The Chairman
NSW Independent Planning Commission
Level 3, 201 Elizabeth Street
SYDNEY NSW 2000
Attention: Steve O'Connor

MP 07_0027 MOD1
MODIFICATION TO SHELL COVE BOAT HARBOUR CONCEPT APPROVAL

The Visual Impact Assessment

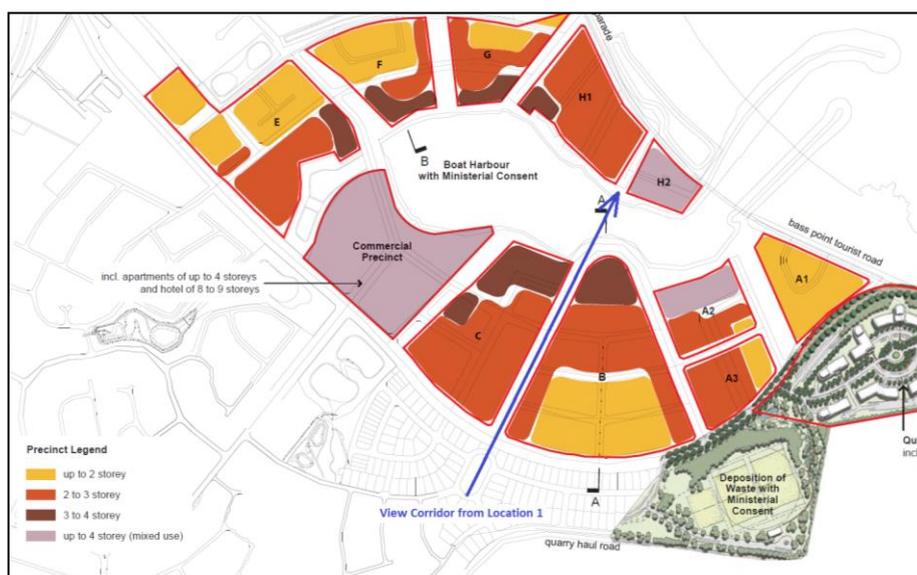
The "Visual Impact Assessment" includes eight (8) photomontages purporting to show a comparison between the Concept Plan Approval and the building form proposed in the proposed modification Application.

The photomontages depict the building forms from relatively distant locations, with one (1) exception. That exception is identified as Location 1, being a view in a north-easterly direction from *Shallows Drive Reserve* (directly opposite No. 50 Shallows Drive).

In an attempt to assess the accuracy of the photomontage in depicting the building heights incorporated in the Concept Plan Approval, I have marked the corresponding view corridor on the approved building height plan (prepared by *LFA (Pacific) Pty Ltd*, dated 26 February 2010) in blue below.

As can be observed, the buildings along either side of The Promontory Drive are depicted in the Concept Plan Approval with the letter "C" in an orange colour as "2 to 3 storeys".

Further, I have zoomed into the view corridors along either side of The Promontory Drive to assess the accuracy of the depiction of the buildings included in Concept Plan Approval (in storeys) relative to the existing buildings.

In my opinion, the images above raise very significant concerns with respect to the accuracy of the photomontages in depicting the building heights incorporated in the Concept Plan

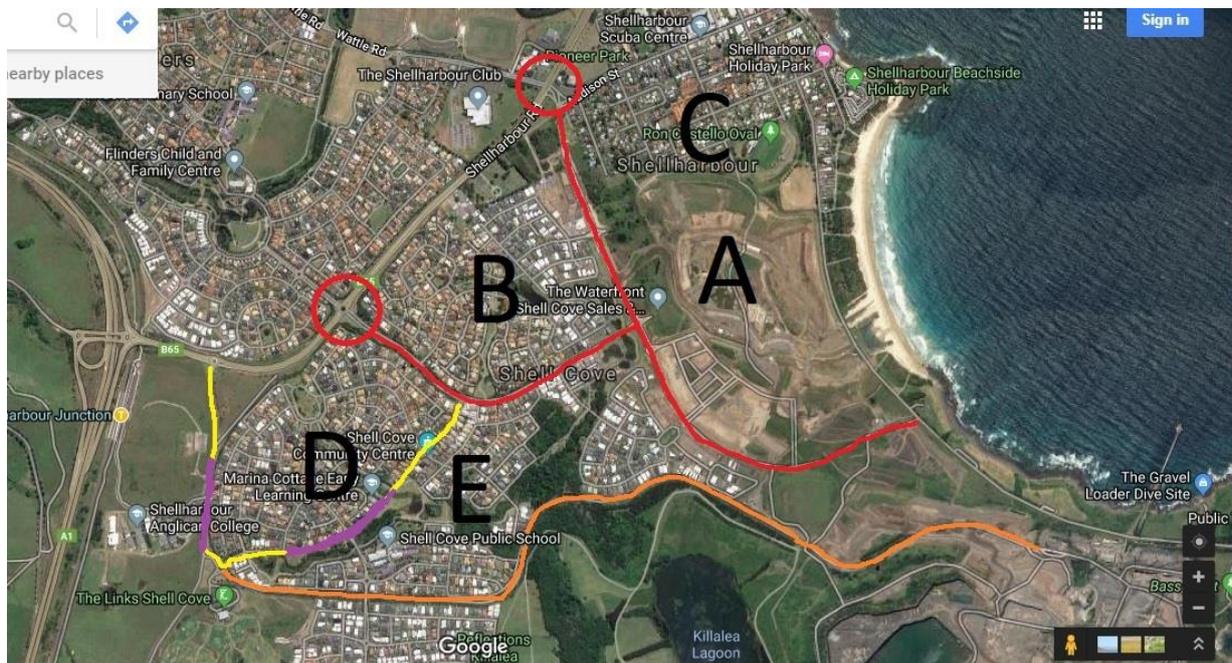
If the visual impact assessment uses 3.75m AHD building ground level and the above height figures in metres to produce a photo montage of the 2011 concept plan, then this may be a possible solution to perform a comparison. The visual impact statement must include these

figures within the document. The IPC should request this be performed ASAP or perform its own visual impact assessment using these figures before making a decision.

The IPC must make sure that Dr Lamb has followed the exact guidelines of the Land and environment court to produce the report.

In addition, the Visual Impact Assessment relies on computer generated depictions of the building heights and not actual tangible structures. The computer-generated montages cannot depict with 100% accuracy what the views will look like. I therefore propose that one temporary pole for each building over 15m high be erected on site and a clearly visible marker be mounted on each pole at the proposed height of the building. This will allow the IPC and residents to accurately judge and photograph the true impact to their view from their home.

Figure 1: Approved Concept Plan

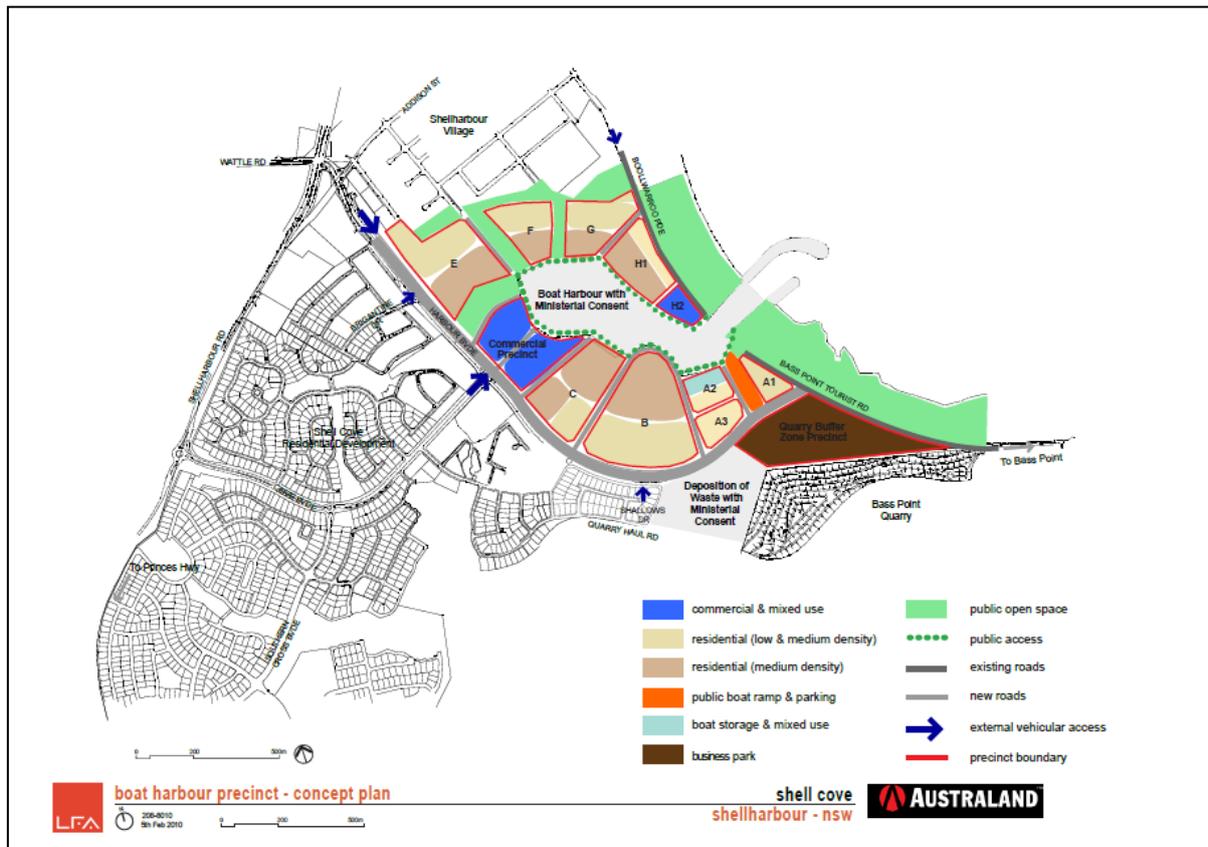
Figure 15 (referred to above) is an image which identifies certain view corridors said to be available to future dwellings within the development site. The image does not include any analysis of (or reference to) the views available from the existing residential neighbourhoods of Shell Cove and Flinders to the west of the site.

2011 : APPROVED CONCEPT PLAN

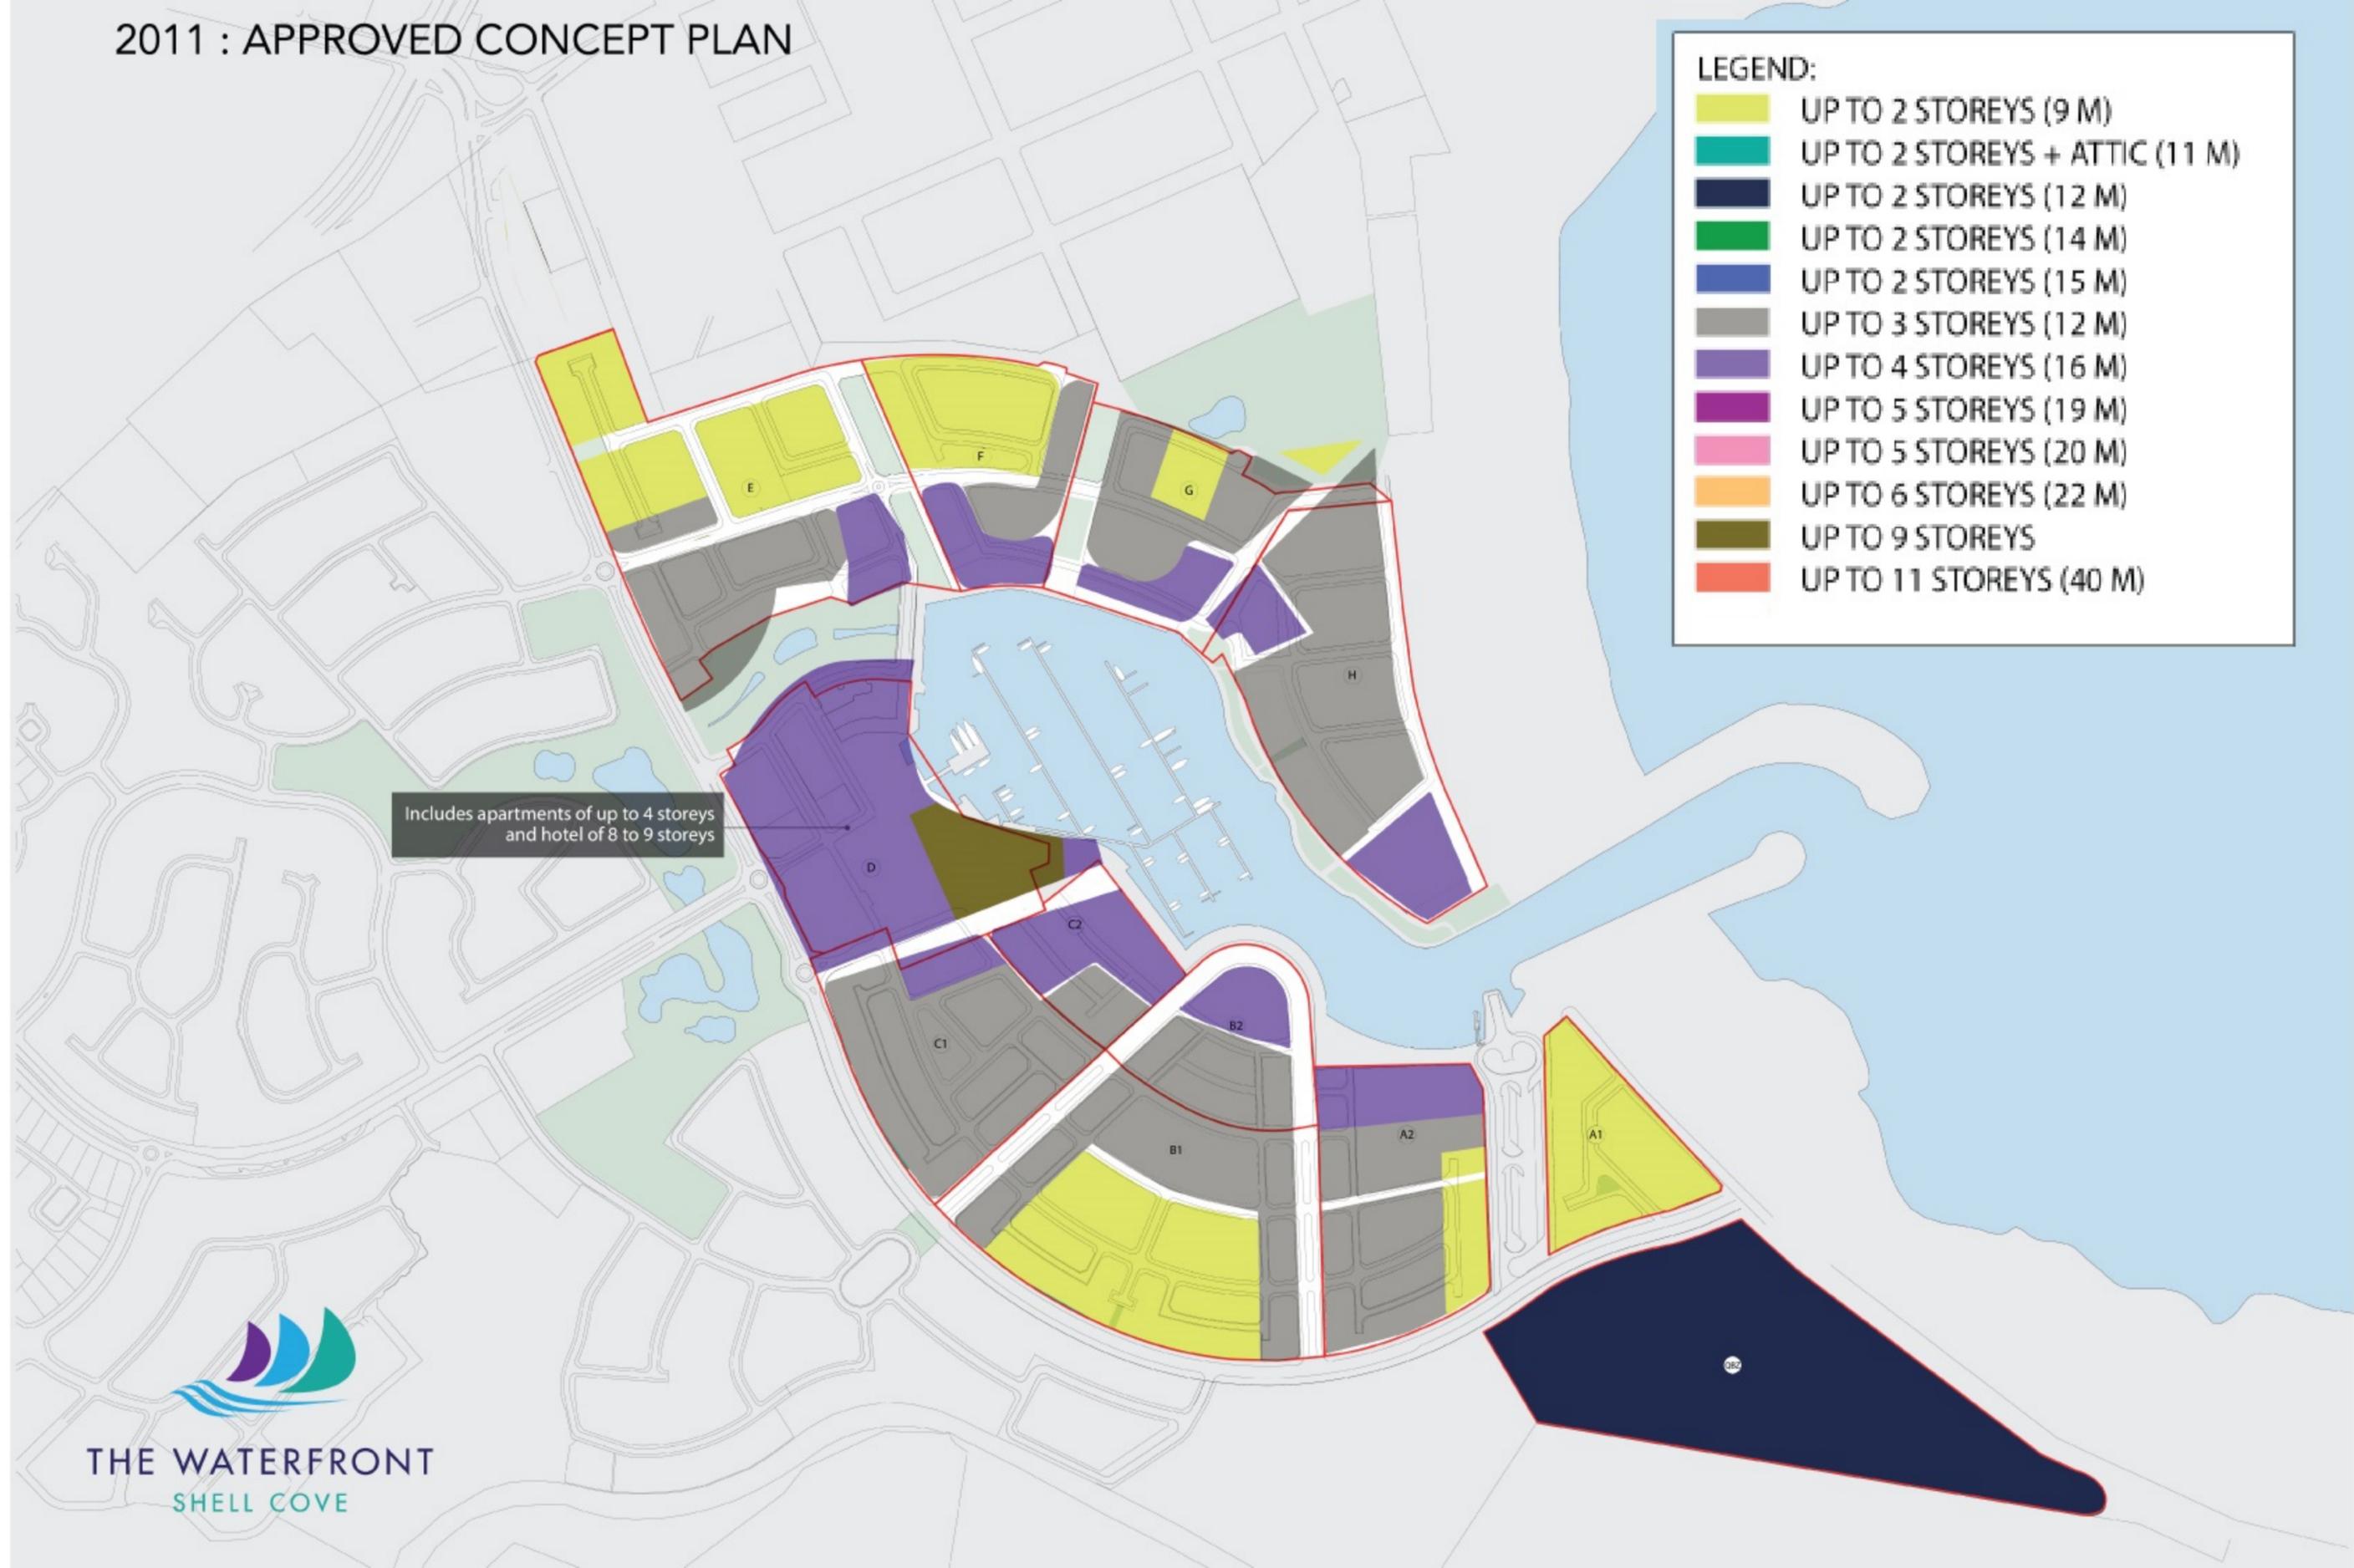
Therefore, according to all the above, my views are highly valued and the impact to them as a result of the modification is unreasonable. From my calculations, the difference in building heights and scale of the proposed modification (as per the diagram below) will definitely impact my views severely, bordering on devastating.
